Technical Bulletin

Model
911 C2/C4

Subject: Fuse Ratings Changes

Number
9004

911 Carrera 2/4 Model 90 Sheet 11
CENTRAL ELECTRIC

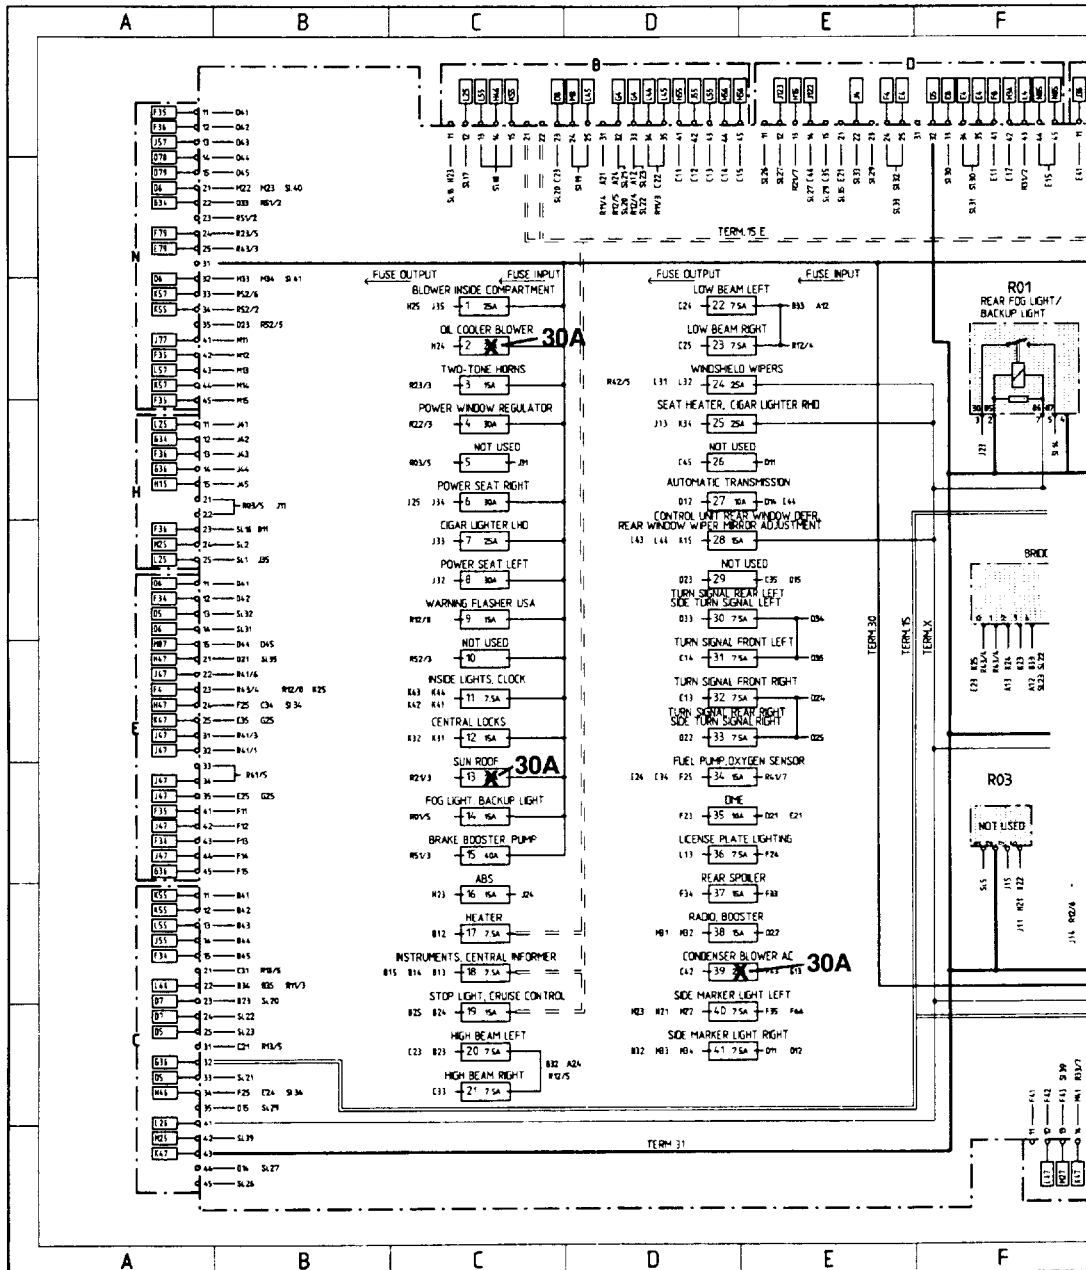
Concern: The following fuse ratings have been re-evaluated and increased from 25 amp to 30 amp.

Fuse number 2 — Oil cooler blower

Fuse number 13 — Sunroof/Cab top

Fuse number 39 — Condenser blower A/C

Please correct your Repair Manual wiring diagrams model year '89 and '90 911 Carrera 2/4, Sheet 11 (see figure on next page). Also the 1990 Wiring Diagram Book (Part Number PNA 000 081) fuse location tab and 911 Carrera 2/4, Sheet 11.

Repair Information: Unfavorable tolerance can cause current draws in excess of 25 amp in the above mentioned systems without damage to the electrical wiring. Fuses number 2, 13 and 39 on the central electric board should be replaced with 30 amp fuses (Part Number 999 607 010 00) during repairs on all '89 model year 911 C4 and early production '90 model year 911 C4 and 911 C2.
